**SECTION 00 91 13**

**ADDENDUM NO. 2**

**Prepared and Issued by Woodard & Curran (Engineer) on behalf of:**  
*City of Marlborough, MA (Owner)*  
*Department of Public Works*

DEPARTMENT OF PUBLIC WORKS  
MARLBOROUGH, MASSACHUSETTS  
MILLHAM WATER TREATMENT PLANT  
UPGRADES

**H-101**

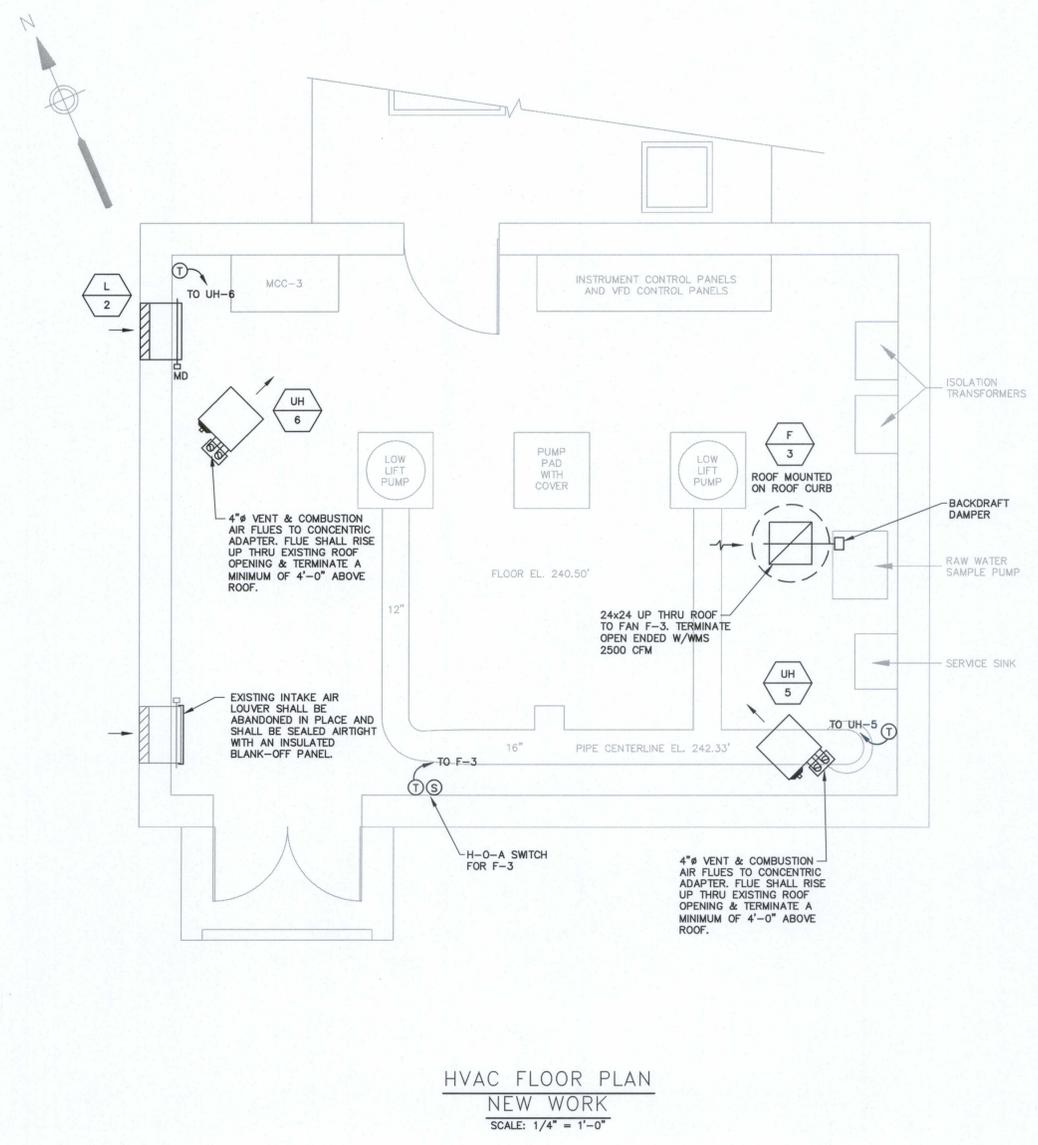
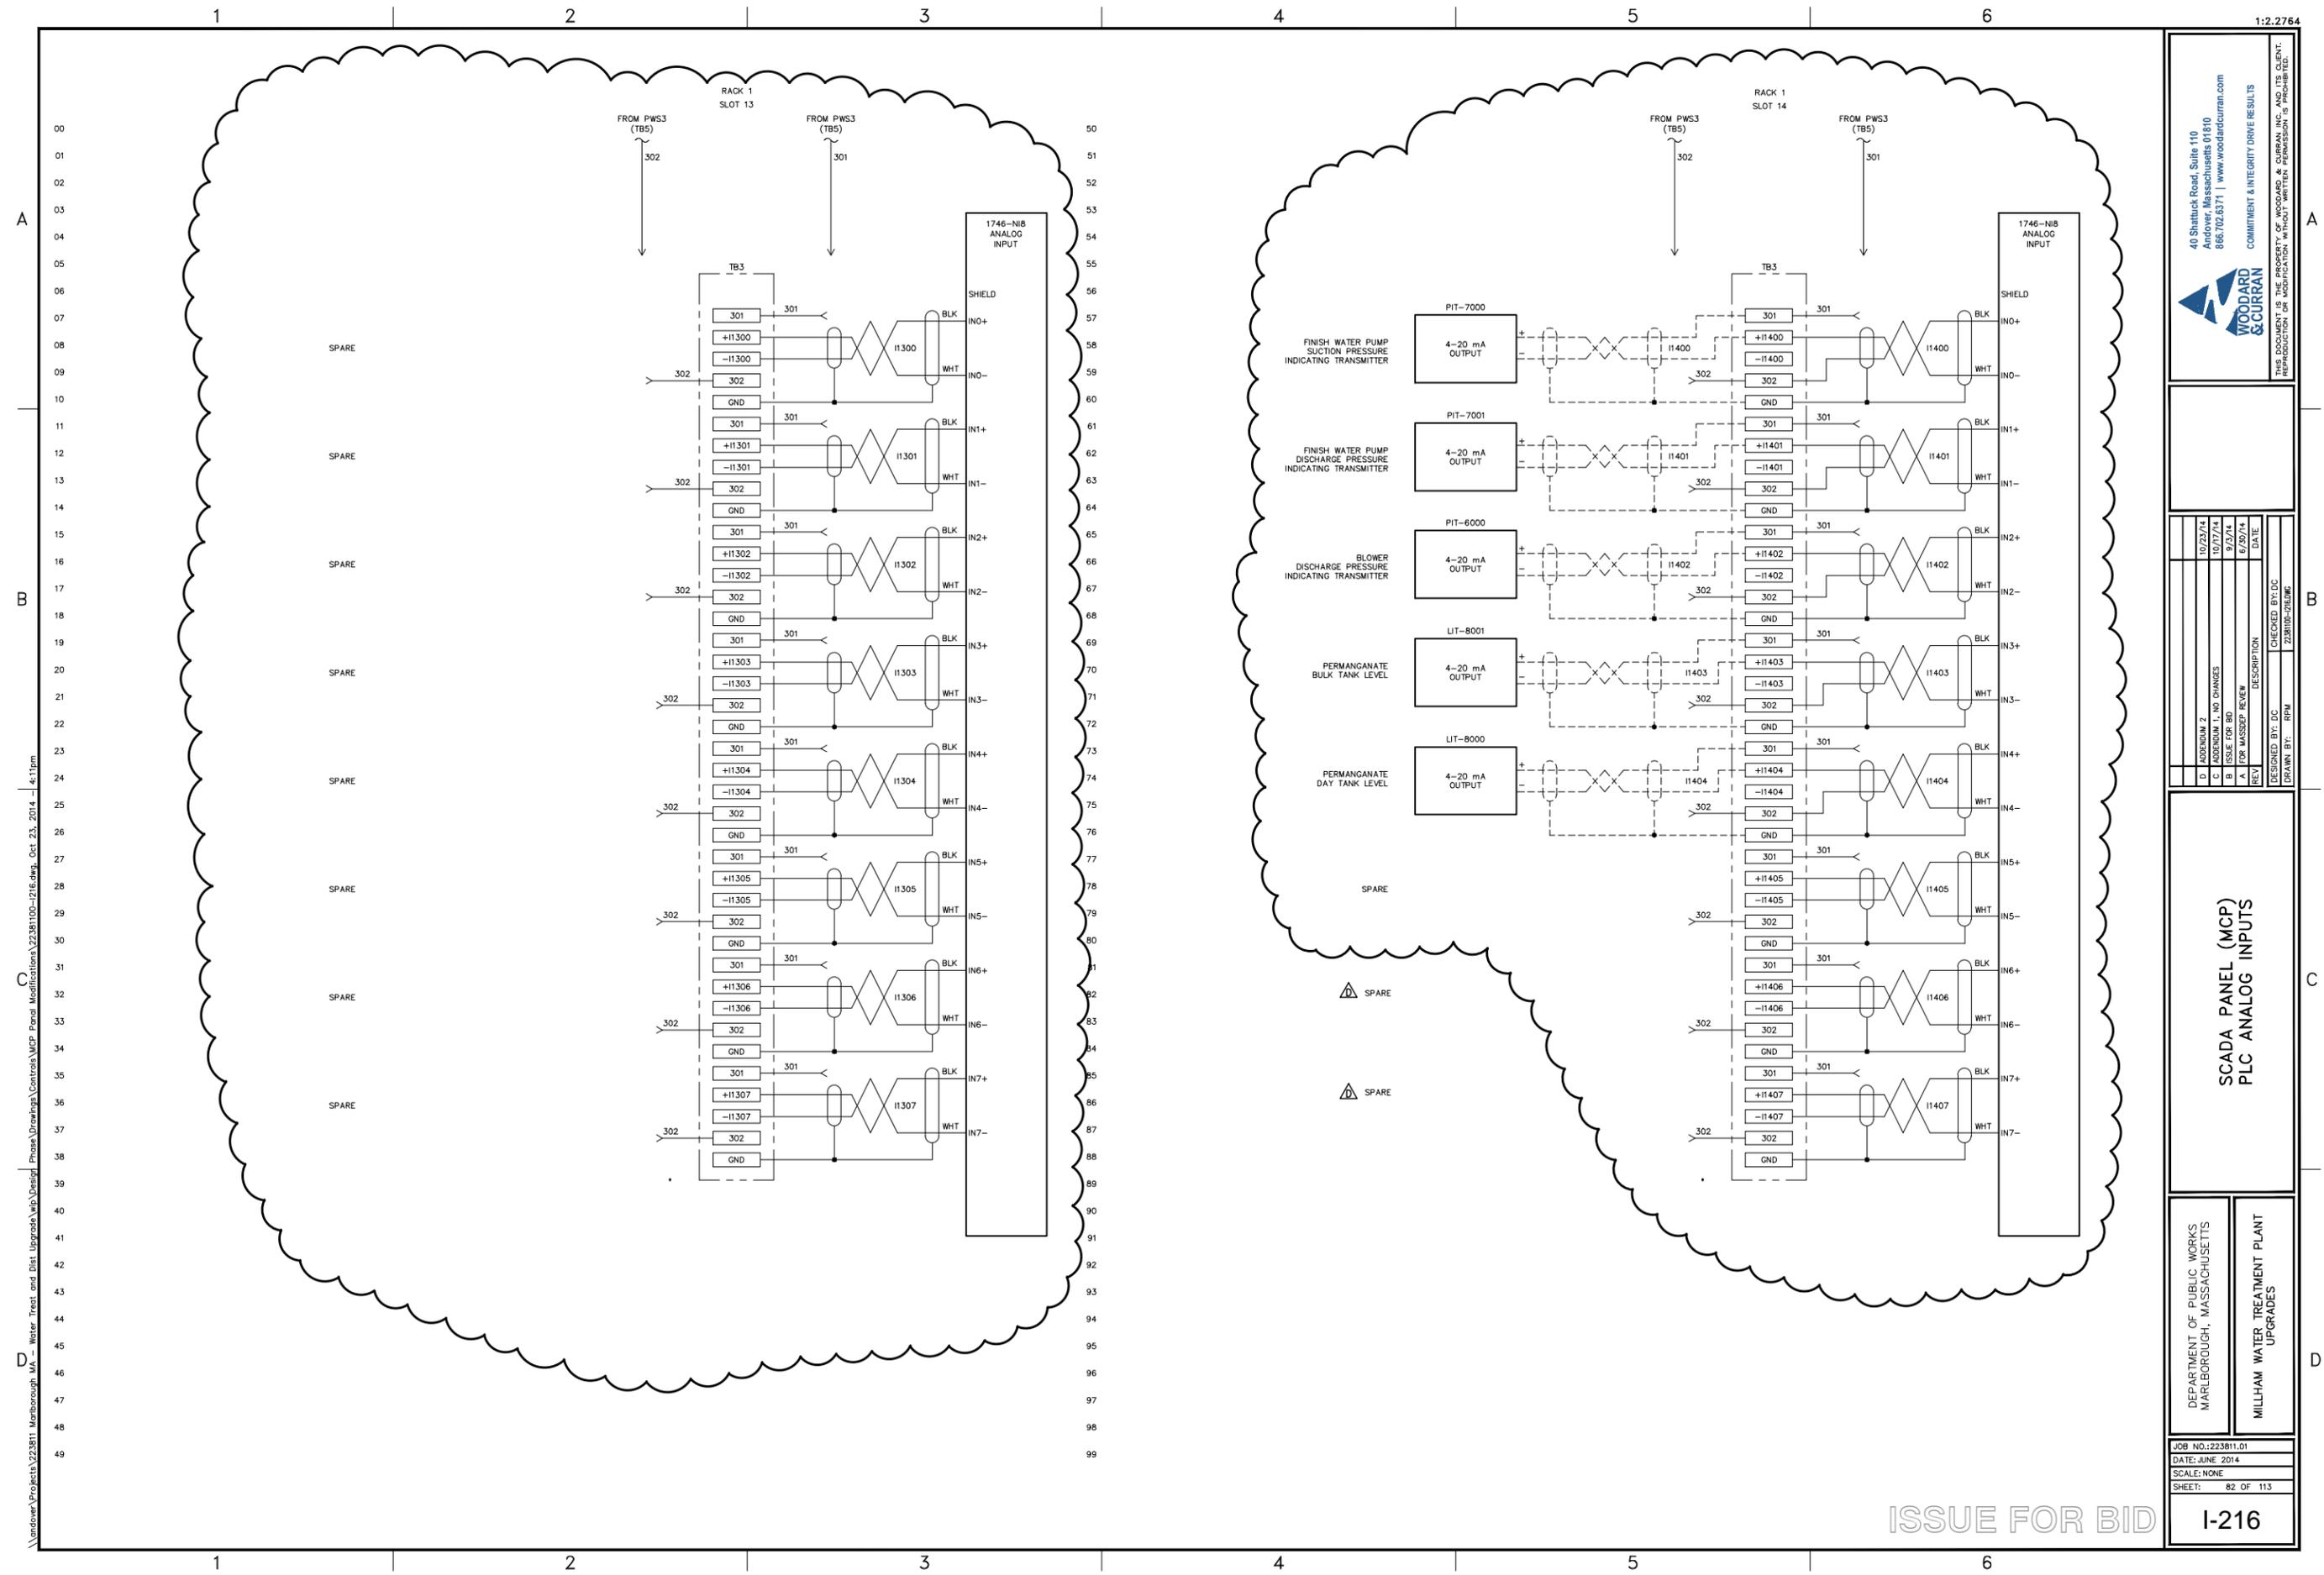
REV	DESCRIPTION	DATE	CHECKED BY: MJ	DATE
D	ADDENDUM NO. 2 (EXISTING EQUIPMENT SHOWN)	10/23/14		
C	ADDENDUM NO. 1 (NO MODIFICATIONS TO THIS SHEET)	10/21/14		
B	ISSUE FOR BID	10/17/14		
A	FOR MASSDP REVIEW	6/20/14
